**Grove City Area School District
Middle School
HVAC Equipment Replacement and Upgrades**

Project No: 25-S43-01

ADDENDUM 1

8/5/2025

A.711

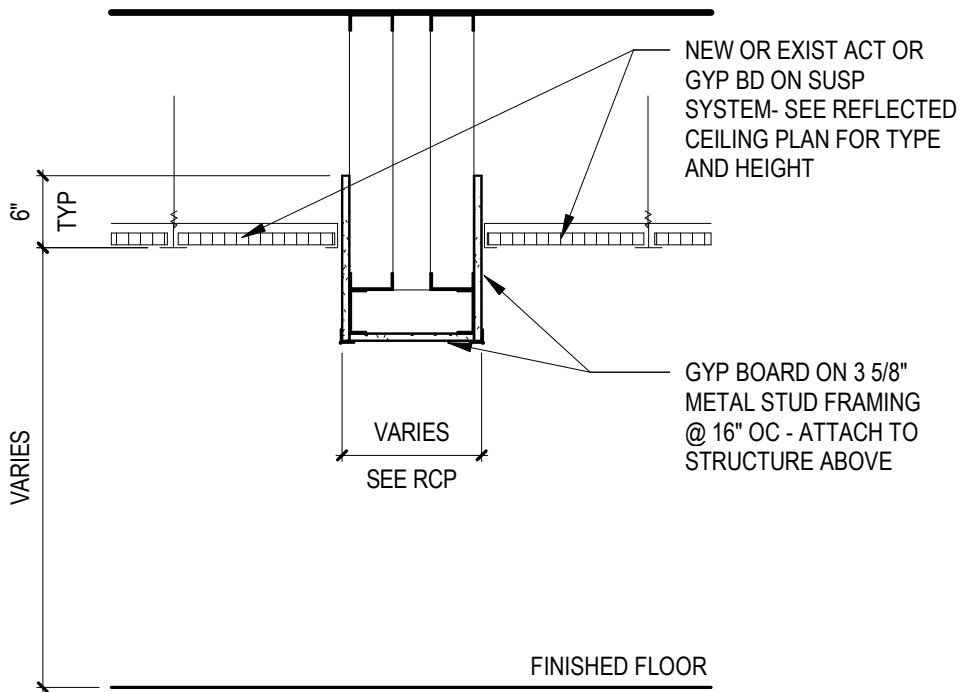
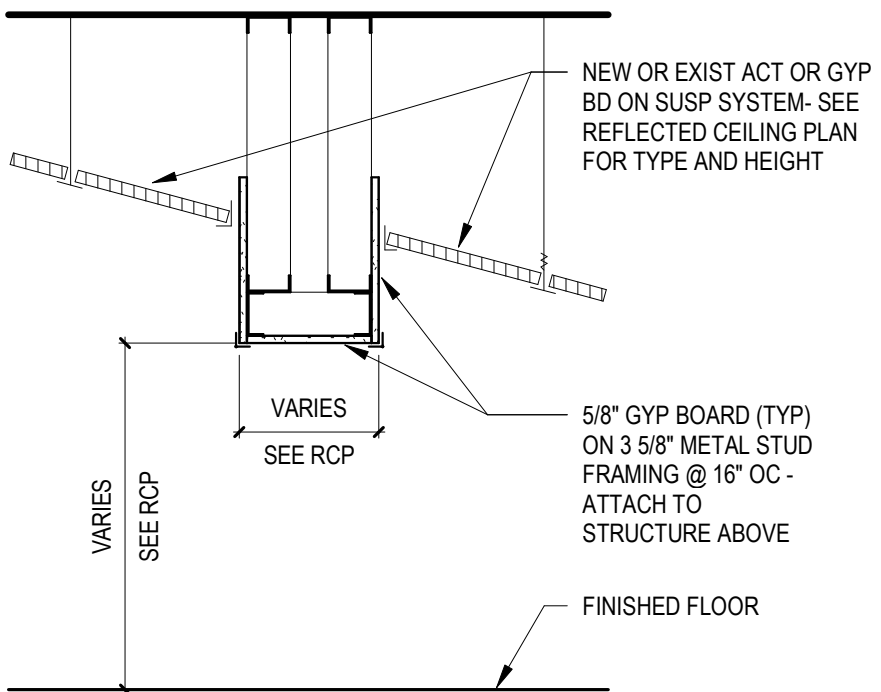
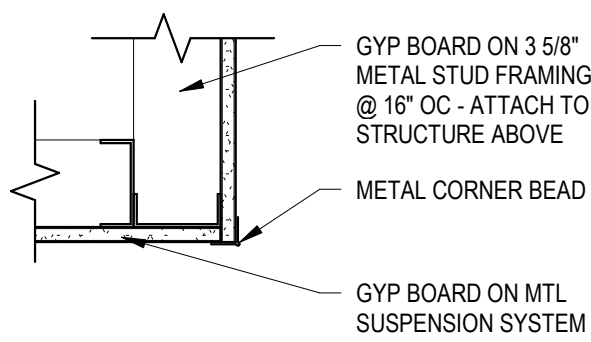
INSTALL SALVAGED TILES. DAMAGED/STAINED CEILING TILES SHALL BE REPLACED WITH NEW TO MATCH EXISTING. Sheets A.711, A.712 and A.713 are replaced with the ones attached to this Addendum.

H.221

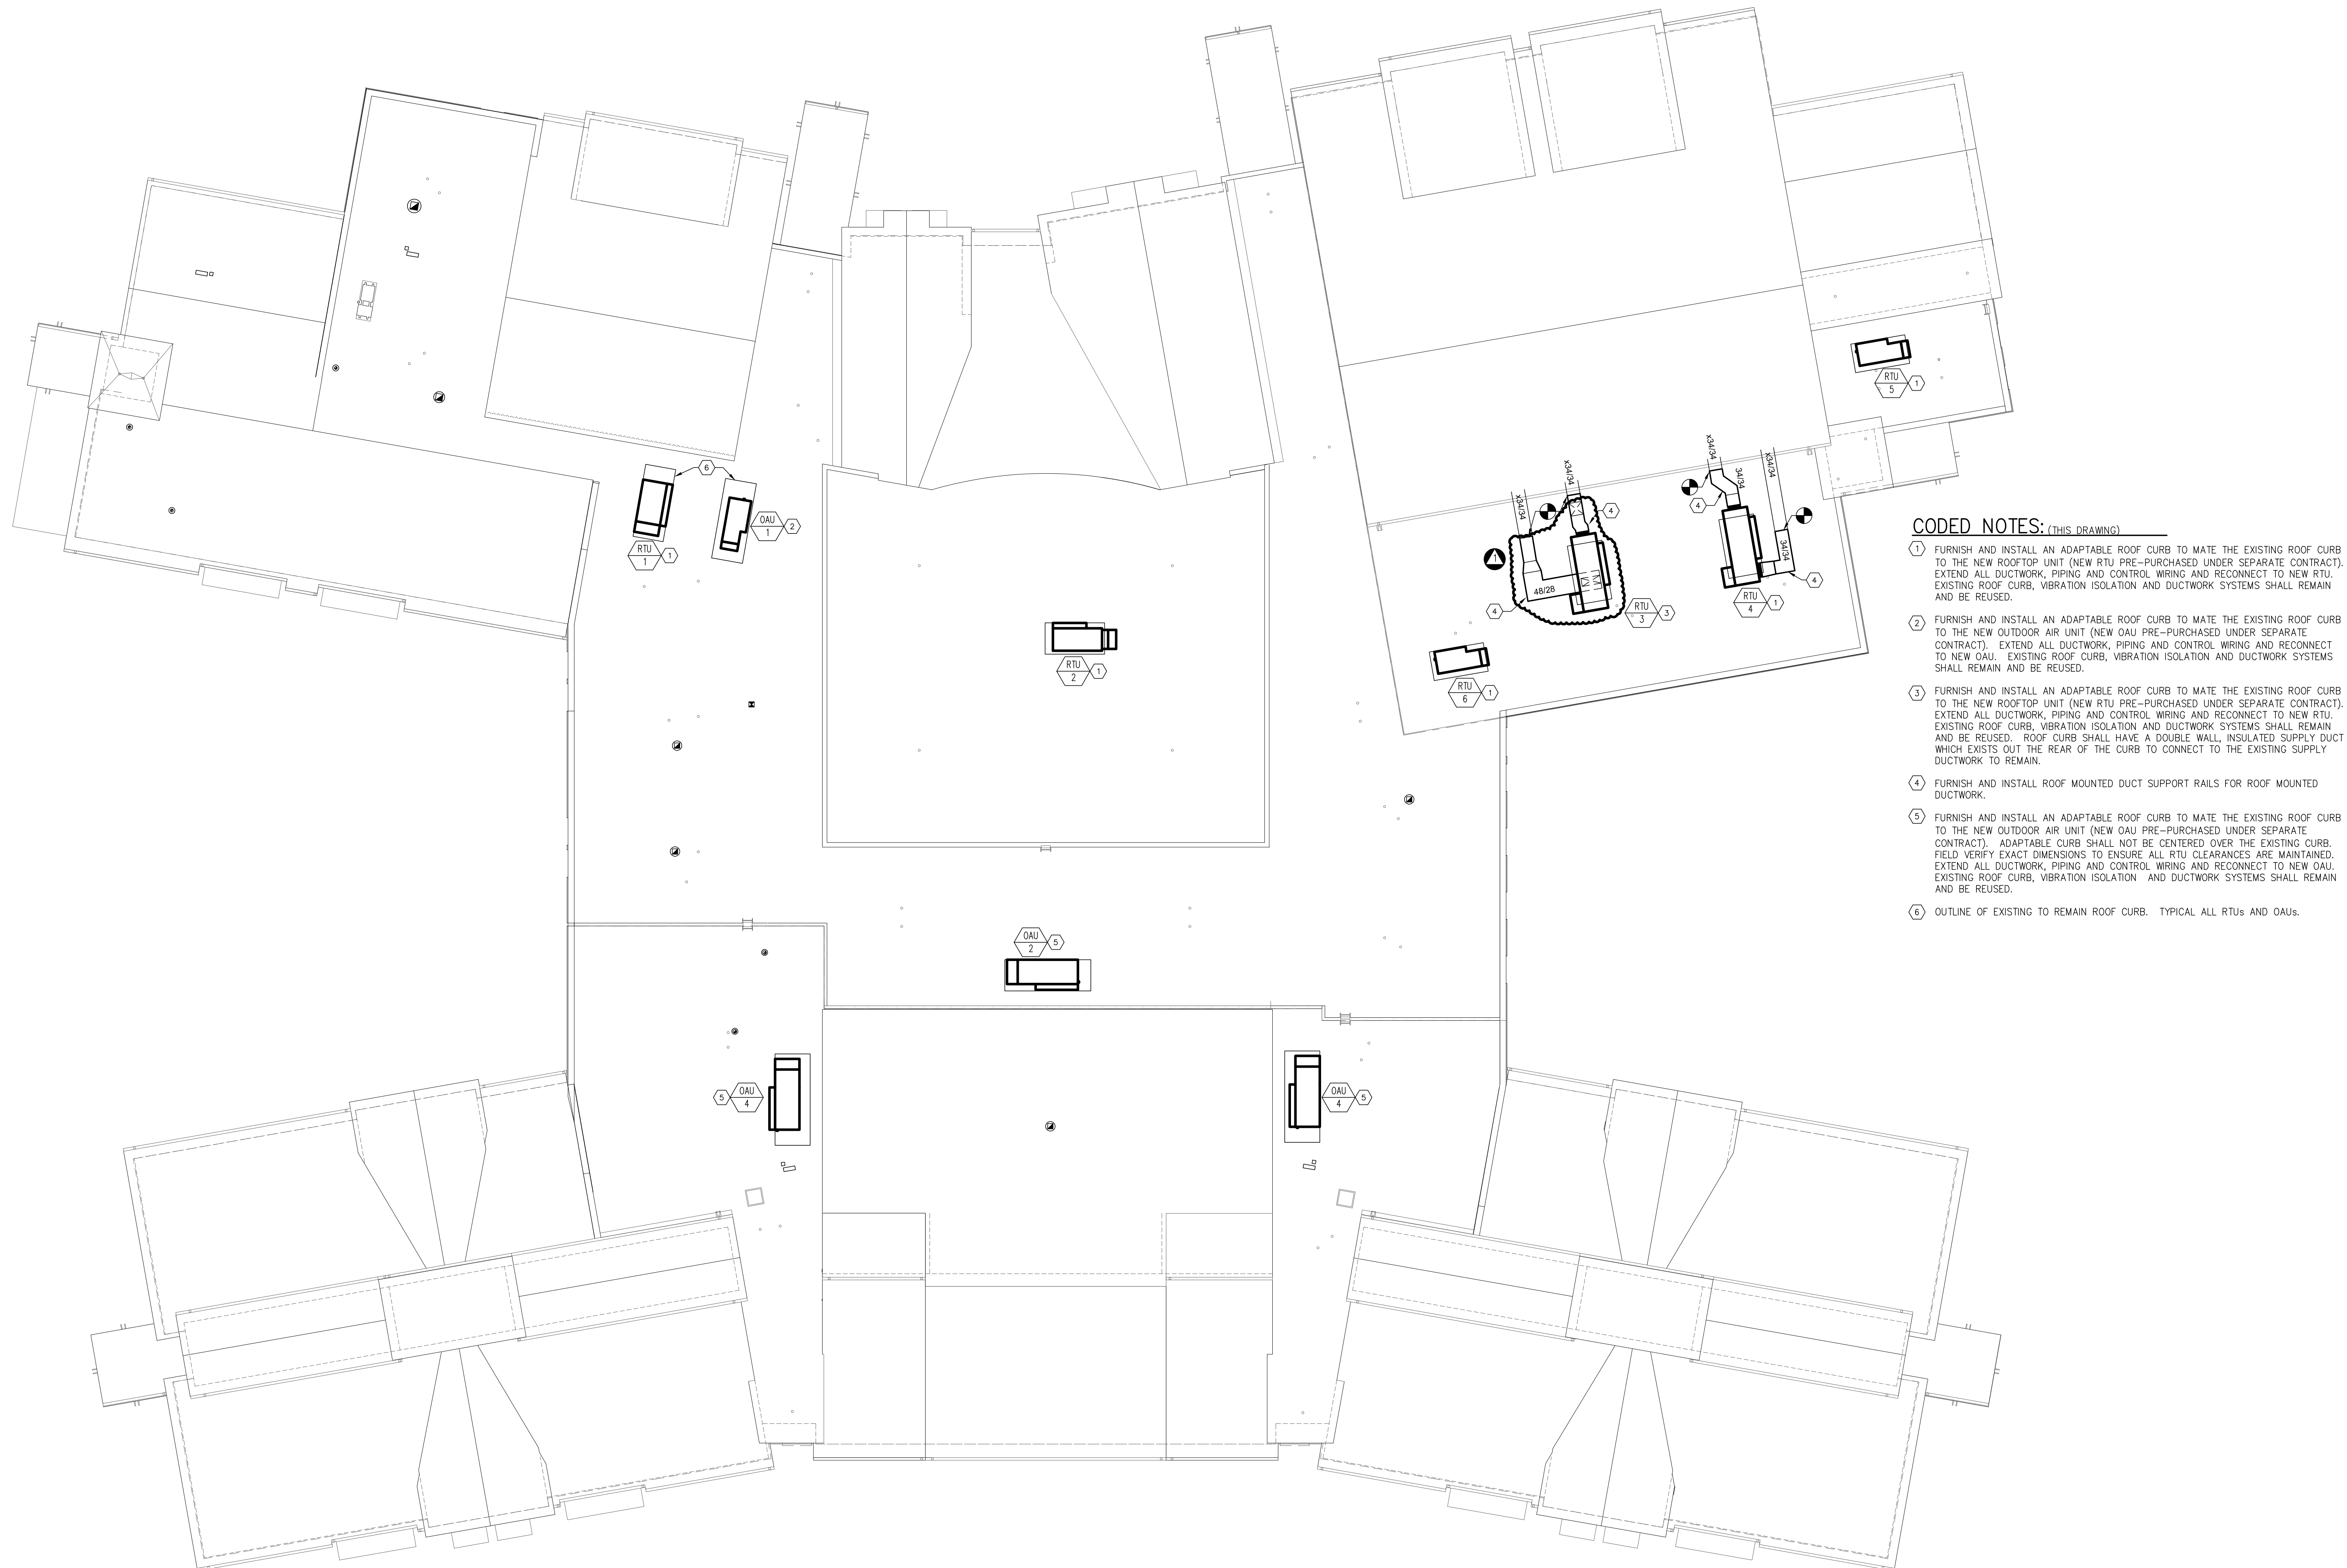
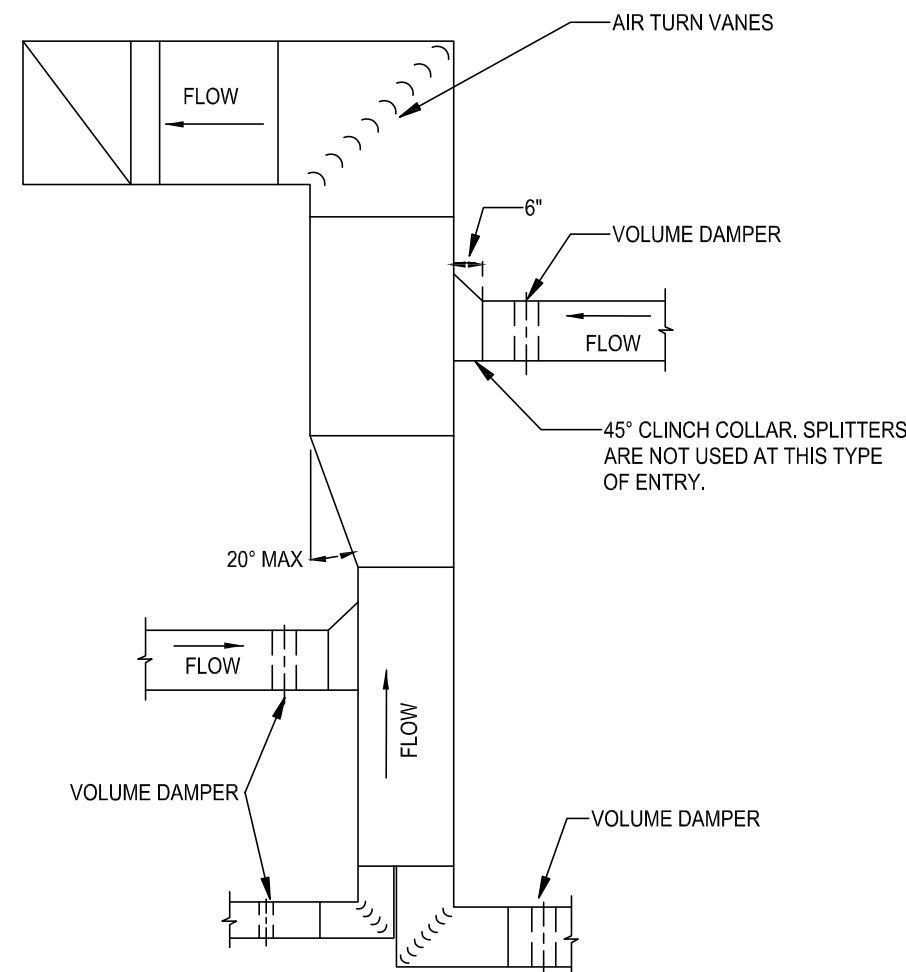
Sheet	Detail	Comments/Changes
H.111	First Floor Demolition Plans HVAC	Coded Note 1 calls for the house keeping pads at the pumps to be removed and replaced. The pads may remain and be reused if the new pumps will fit onto the existing pads and be properly secured in place and the installation will not require any unusual piping offsets or bends in the flexible connectors that do not meet the manufacturer's installation instructions.
H.121	Roof Demolition Plan – HVAC	Coded Note 3 calls for the roof mounted ductwork and supports to be removed. Supports rails that are embedded in the roof may remain and be reused.
H.221	Roof Plan - HVAC	The orientation of RTU-3 has been changed. The original design had the supply discharge of the RTU exiting the unit through the bottom and then running through the curb adaptor before exiting to the roof, and the return ductwork connecting into the side of the RTU. The new configuration has the RTU rotated 180 degrees, the supply discharge is through the sidewall of the unit, with the return duct connection in the bottom of the unit. This configuration will required the return duct to penetrate the sidewall of the curb adaptor. Sheet H.221 is replaced with the one attached to this Addendum.

Per the coded notes on H.221, we are to re-use the existing vibration isolation for the new RTUs. Per the
curb adapter detail on H.511, the vibration isolation is to be moved to the top of the curb adapter.

ROOF CURB - TRANSITION ADAPTER DETAIL
NO SCALE

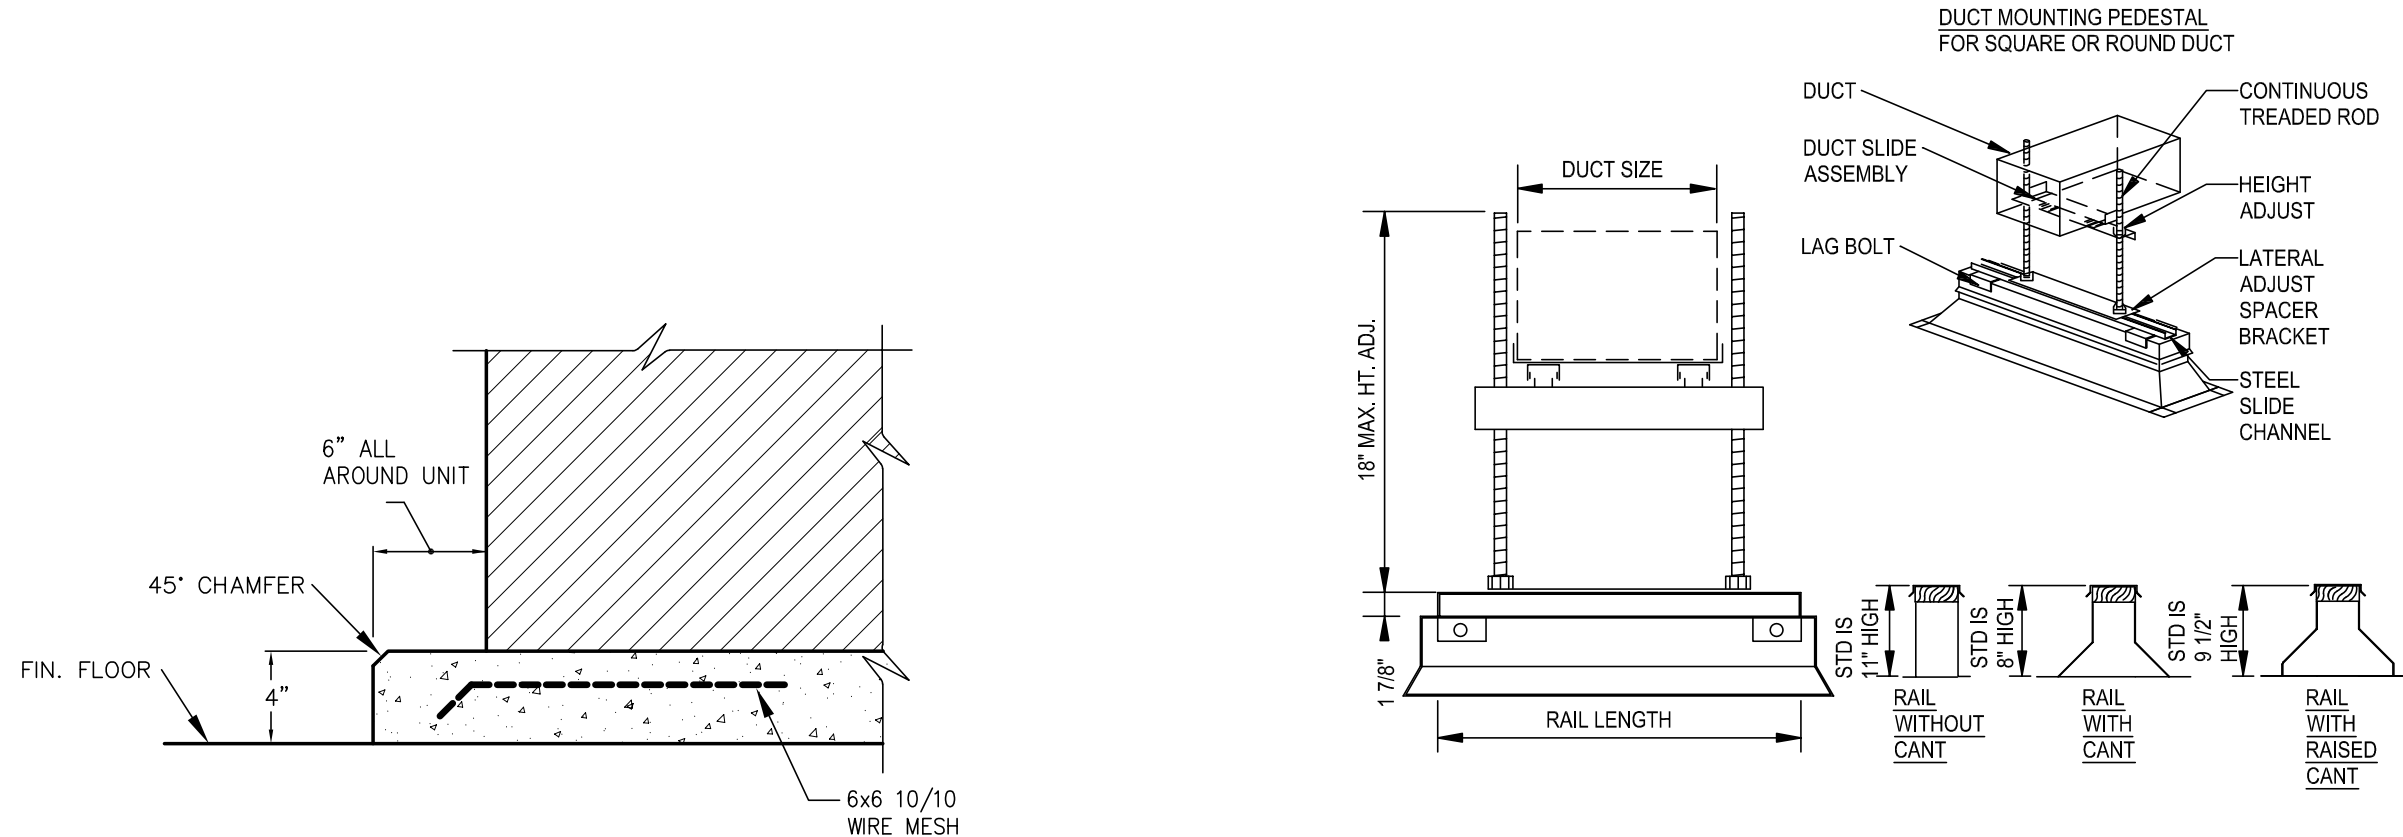
H.511	Details – HVAC Roof Curb – Transition Adapter Detail	The original detail indicated that the existing isolation rails were to be reused and showed the isolators resting on top of the adapter curb and below the rooftop equipment. The detail has been updated to remove the isolators on top of the adapter curb and to indicate that the existing isolators on the existing curb are to remain and be reused. Refer to Coded Note 8 on revised detail on drawing. Sheet H.511 is replaced with the one attached to this Addendum.

Existing vibration isolation can not be modified to fit a different size curb nor is it recommended as isolation
is designed per size and weight of the units they support. Please clarify.

- TRANSITION CURB SHALL BE DOUBLE WALL WITH 2" THICK INSULATION.
- THE EXISTING CURB HAS INTEGRAL POINT LOADED SPRING VIBRATION ISOLATORS. THESE ISOLATORS SHALL BE FIELD ADJUSTED BY THE CONTRACTOR AS NEEDED AFTER THE ADAPTER CURB AND NEW UNIT HAS BEEN INSTALLED.

The existing curb has integral point loaded spring vibration isolators. These isolators can be field adjusted
by the contractor as needed after the adapter curb and new unit have been installed.

The detail on H.511 will be updated to reflect this.
